U. S. ATOMIC ENERGY COMMISSION
DIRECTORATE OF REGULATORY OPERATIONS
REGION I

RO Inspection Report No.: 50-219/73-07

Licensee: Jersey Central Power & Light Company

Location: Forked River, New Jersey

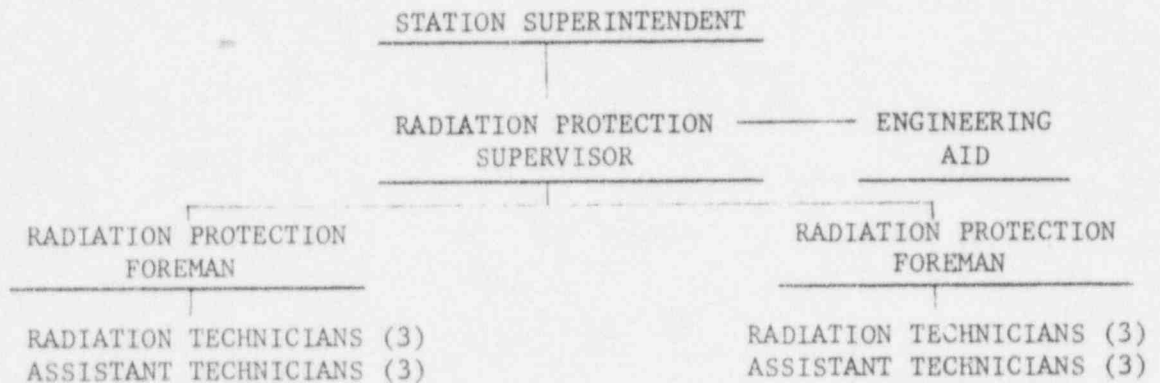
- a. As described by the licensee, efforts to improve management controls in the areas of radiation protection are currently under review. Priority attention is being given to re-organization which will include additional supervisory positions along with additions at the technician grade level. The organizational alignment, as described by the licensee, is shown below:

- b. The licensee stated that the individual named to the Radiation Protection Supervisor (RPS) position would be a certified Health Physicist, with vested responsibility for the radiation protection program. This responsibility will be written into the position description. Reportedly, candidate interviews have been conducted for the RPS position and resume' reviews are currently being made
